SUBJECT: Statutory public meeting and recommendation report for an official plan amendment, zoning by-law amendment and plan of subdivision for 2294 & 2300 Queensway Drive

Report Number: PL-17-20

File Numbers: 505-05/19, 520-10/19, & 510-02/19 (24T-19002/B)

Figure 2 – Proposed Site Layout

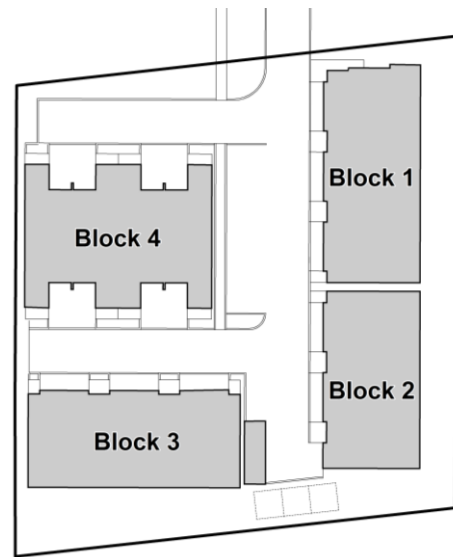
The submitted materials for the subject applications show a part of Block 1 (containing one unit) and site-critical infrastructure (including manholes and catchbasins) within the City and MTO's required 7.5 m setback from Queensway Drive.

However, Transportation staff comment that the two northerly visitor parking spaces (V1 and V2) proposed are situated too close to proposed access. As a result, the two northerly spaces are recommended to be eliminated.

Lastly, Transportation staff also comment that the proposed driveways of the back-to-back townhouses are deficient in length. 6.3 m is proposed, whereas the Zoning By-law requires a minimum driveway length of 6.7 m for POTLs. The required 6.7 m length ensures that longer vehicles (such as pickup trucks) can park without obstructing the private laneway.

Furthermore, Fire Services staff comment that the siting of Block 1 from the private laneway does not comply with the Ontario Building Code. Principal entrances are required to be setback at least 3 m from a fire access route. The proposed entrances of Block 1 are located 2.6 m from the fire access route.

A 26 m² “Garbage Room” building (enclosed and roofed over) is proposed to be sited at a reduced setback from south property line (6 m, whereas 12 m is required). According to the submitted waste management report, this building is intended to store general waste, recycling and organic waste for the proposed development. Three hydro transformers are sited 1.5 m south of the garbage room and surrounded by a retaining wall located approximately 1.5 m from the south property line. The siting of these features is problematic because Urban Forestry & Landscaping staff comment that there is insufficient space between the retaining wall and lot line for the proposed privacy fence and proposed cedar hedge. As such, Planning staff are concerned that the odour and noise impacts of the garbage room, and light trespass from the private driveway onto adjacent properties will be unmitigated.

The proposed garbage room does not comply with the Zoning By-law’s setback requirements from the south property line and from Block 3. The garbage room is proposed to be located 60 cm from Unit 12 of Block 3 (directly under a second storey window) and 6 m from the south property line. Staff do not support the proximity of this building to Block 3 as it will result in negative odour and noise impacts on Unit 12, and the gap between this building and Block 3 creates a space for people, objects, litter, and wildlife to get trapped. This building should be relocated so as to provide landscaping to buffer this building from the proposed townhouses.

City Transportation - City Transportation staff comment that the 7.5 m clear zone at the front of the property now includes Units 1 and 2 as well as the common driveway access for Units 22, 23, 24 and 25. This clear zone was intended to be free from site-critical features and must be amended. Units 1 and 2 must be removed from the site plan. Transportation Services has no concerns if the east-west private road to Units 22-25 exists in the clear zone. If the road is widened in the future, this access may be removed, and the driveways for those units would be extended to be accessed from Queensway Drive.

Visitor spots 1 and 2 on the site plan should also be removed as they are too close to the proposed access. Also, driveways on the Block 4 units should be 6.7m in length instead of 6.3 m.

The MTO would consider accepting a revised application that is similar to the May 2019 concept, if the proposal is revised to keep the 7.5 m block free and clear of buildings and site-critical infrastructure, and if the driveways of the Block 4 units are redesigned to project outwards to Queensway Drive, rather than share a common element driveway. The north end unit of Block 1 (as shown on the May 2019 concept plan) should be revised to have a front-facing porch/door entrance, as opposed to the side-facing porch/door entrance.
